# UNITED STATES PATENT AND TRADEMARK OFFICE

APPLICATION NO.	FILING DATE	FIRST NAMED INVENTOR	ATTORNEY DOCKET NO.	CONFIRMATION NO.
10/612,374	07/01/2003	Ki Rin Sung	DE-1489	3709
7590	07/14/2005		EXAMINER	
David A. Einhom, Esq. Anderson Kill & Olick, P.C. 1251 Avenue of the Americas New York, NY 10020			HAWK, NOAH CHANDLER	
			ART UNIT	PAPER NUMBER
			3637

<b>Office Action Summary</b>	<b>Application No.</b> 10/612,374	<b>Applicant(s)</b> SUNG, KI RIN	
	<b>Examiner</b> Noah C. Hawk	<b>Art Unit</b> 3637

## **DETAILED ACTION**

*FIG. 6**Canfield, Figure 6*

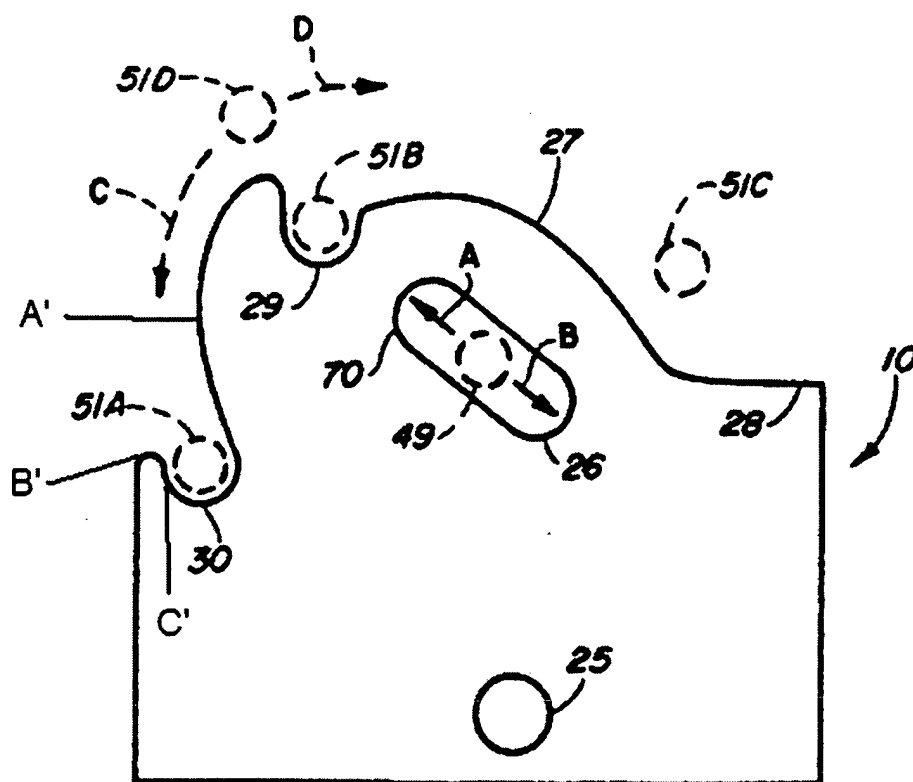
14. Claims 7-10 are rejected under 35 U.S.C. 103(a) as being unpatentable over the applicant's disclosed prior art as applied to claim 6 above, and further in view of Canfield. The disclosed prior art does not teach a curved guide surface, a horizontally extending guide opening, a support portion at a lowest portion of the guide surface, or a

front protrusion opposite the guide surface. Canfield teaches providing a bracket (10) with a curved guide surface (A'), a linear and relatively horizontal extended guide opening (26) for guiding one of the hinge axes, a support portion (30) which is disposed at the lowest portion of the guide surface and a front protrusion (B') connected to the support portion and opposite to the guide surface. It would have been obvious at the time of invention to one skilled in the art to modify the disclosed prior art to use the bracket as disclosed by Canfield in order to improve the ease of opening the cover.
